STAFF RECOMMENDATION

1111 Shelby Avenue

October 21, 2020

Application: New Construction—Addition and Outbuilding; Setback Determination

SITE PLAN

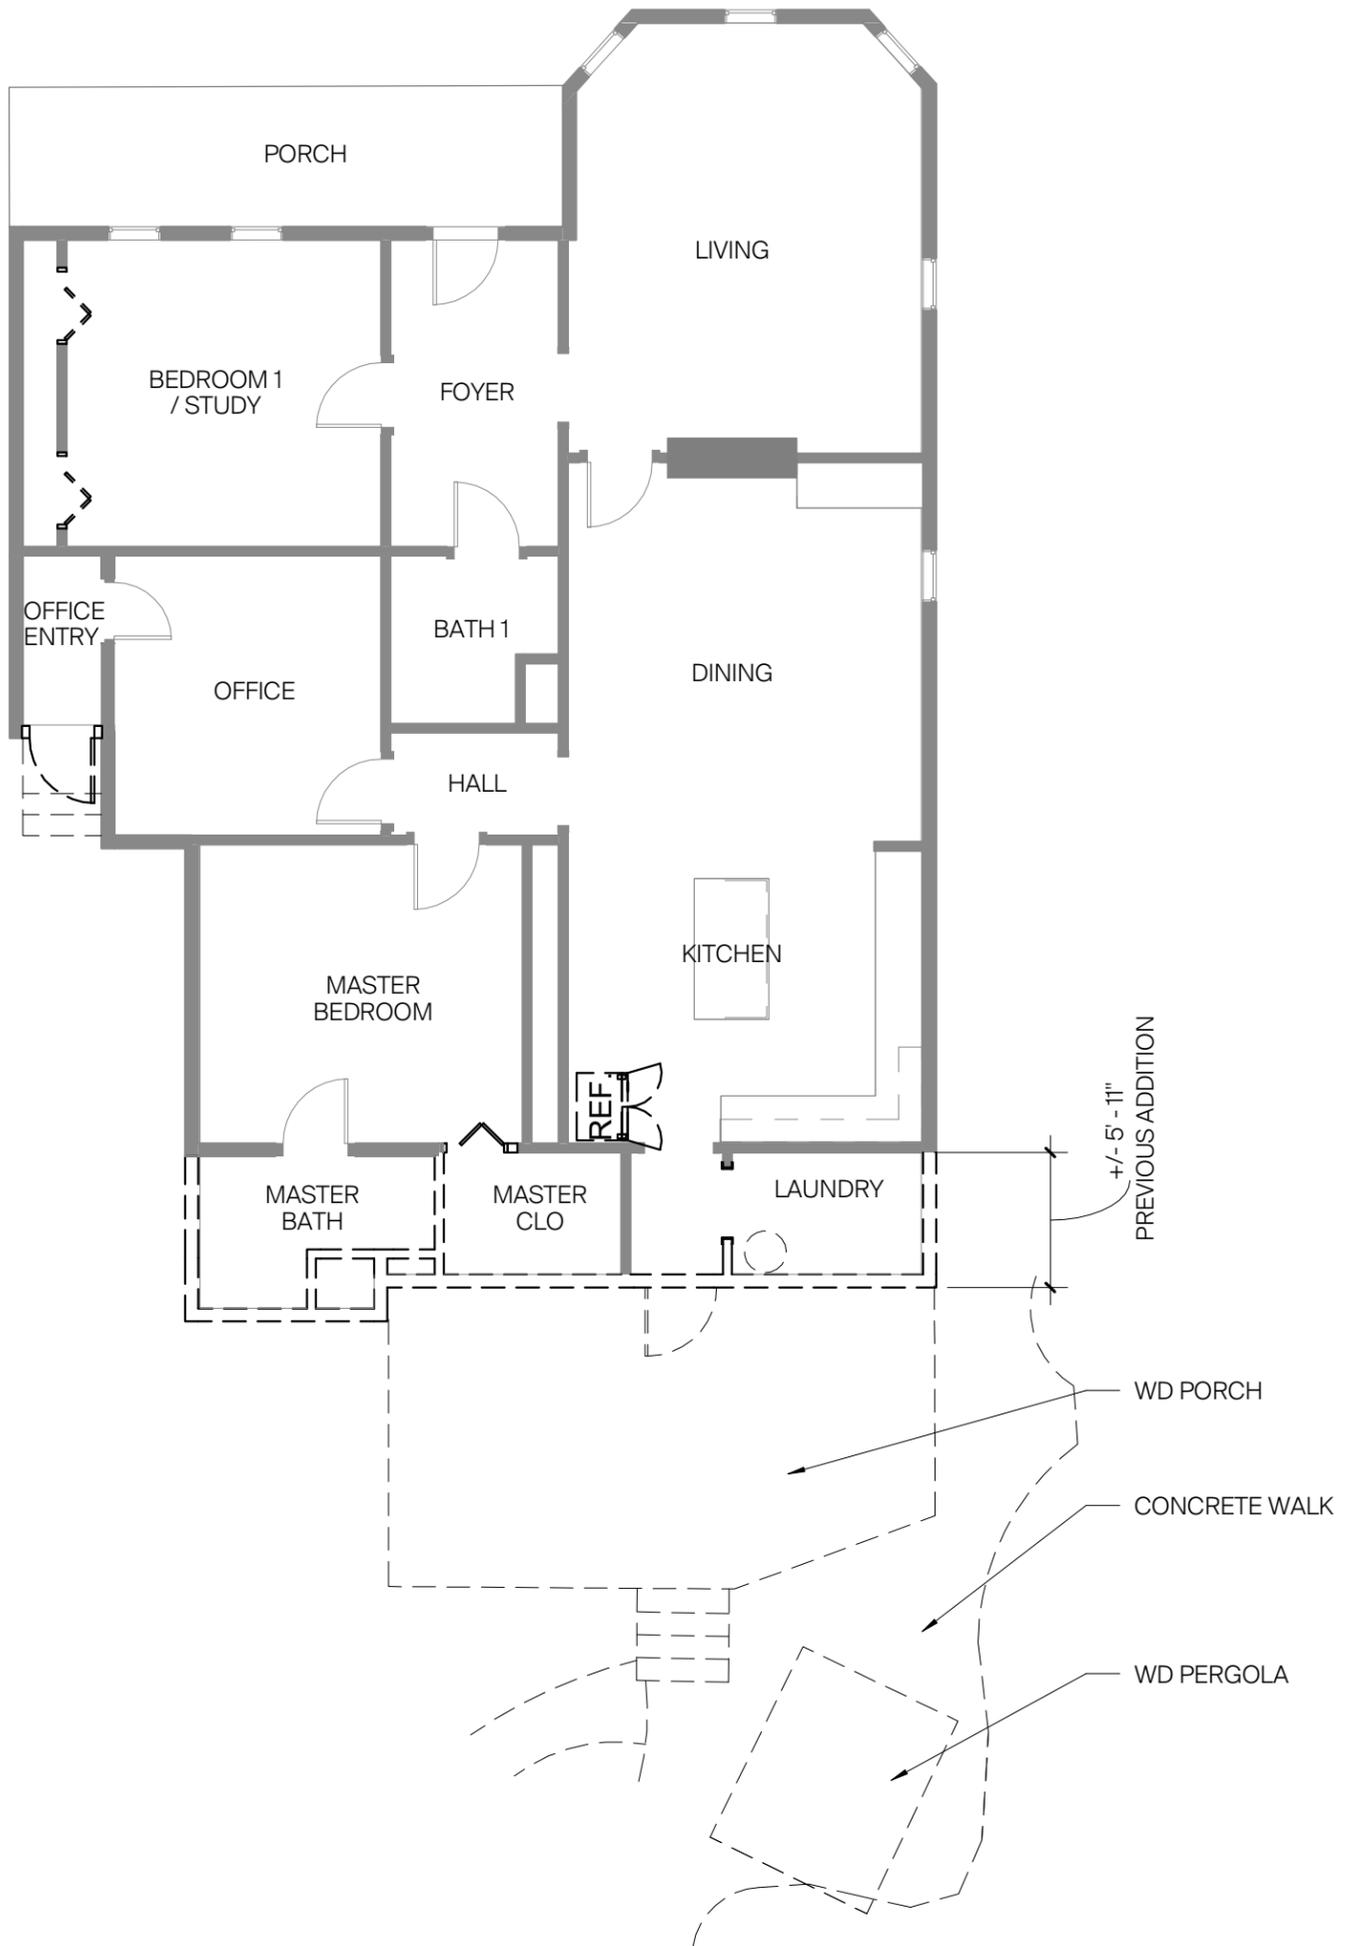
Setback & Rhythm of Spacing: Although the addition matches the width of the historic house, the left side of the addition will not meet the current setback requirement because the house is shifted to the left side of the lot. The left side setback of the addition will be three feet, ten inches (3'-10"), matching that of the historic house. The right side setback will be six feet (6'), which also matches the historic house and meets the standard requirement.

Because the addition matches the width of the existing house, the addition will not impact the perceived rhythm of spacing between houses, therefore staff finds that the setbacks for the proposed addition will meet section II.B.3 of the design guidelines.

SOUTH ELEVATION - GARAGE

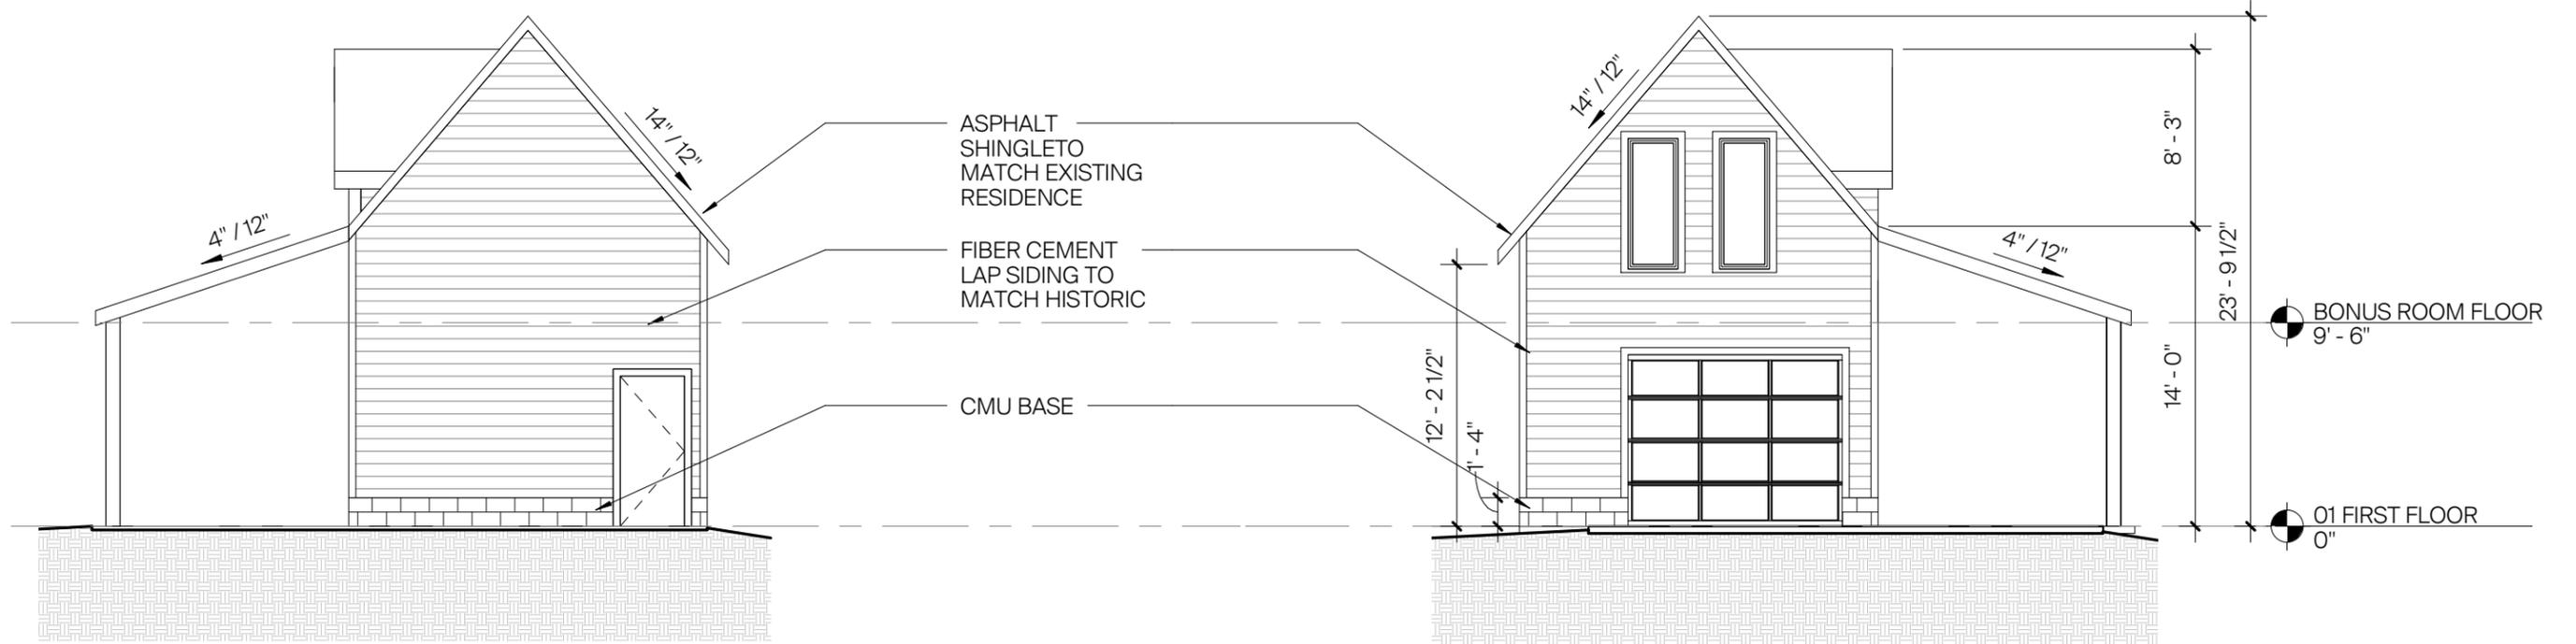
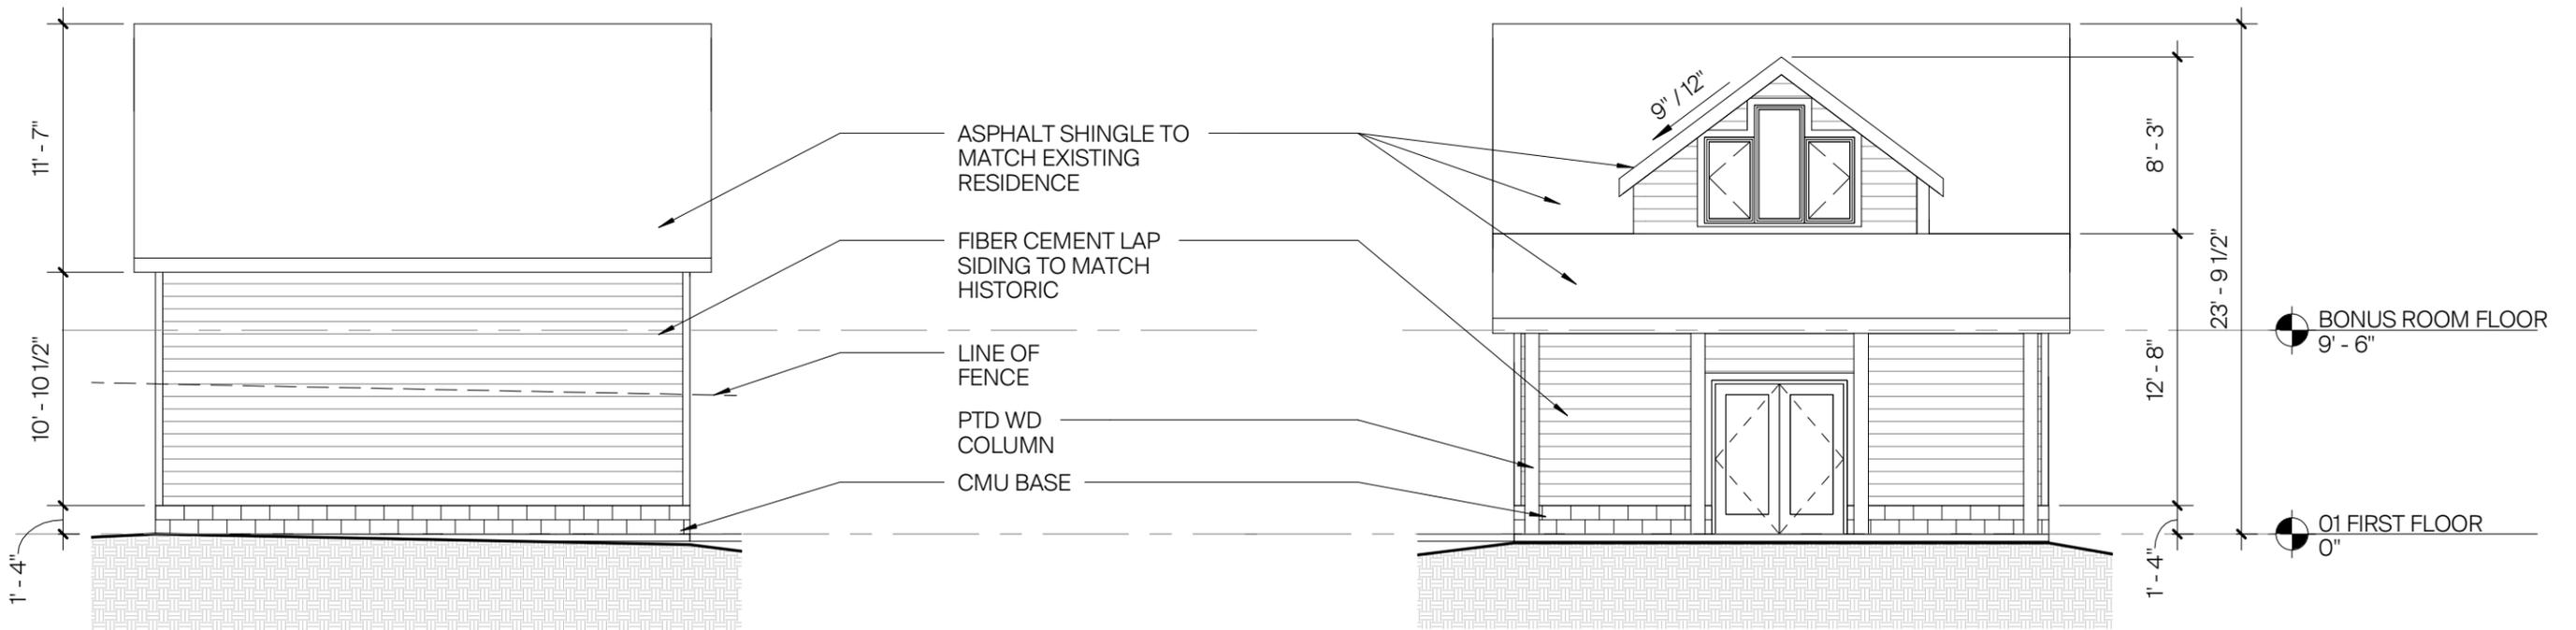
Potential 1-Story or 1.5-Story Outbuilding	Proposed Outbuilding
Ridge Height	22' (floor-roof ridge)	23'-10" (floor-roof ridge)
Eave Height	10'	9'-6" on carport side 12' on garage side

The footprint size of the proposed outbuilding meets the design guidelines, but the eave height and roof height are taller than the design guidelines permit for outbuildings behind one-story houses.

With the condition that the roof height does not exceed twenty-two feet (22'), which is the height of the house from floor level to roof peak, and that the eave height does not exceed ten feet (10') above the outbuilding floor level, Staff finds that the application meets Section II.B.8.a. of the design guidelines for height and scale.
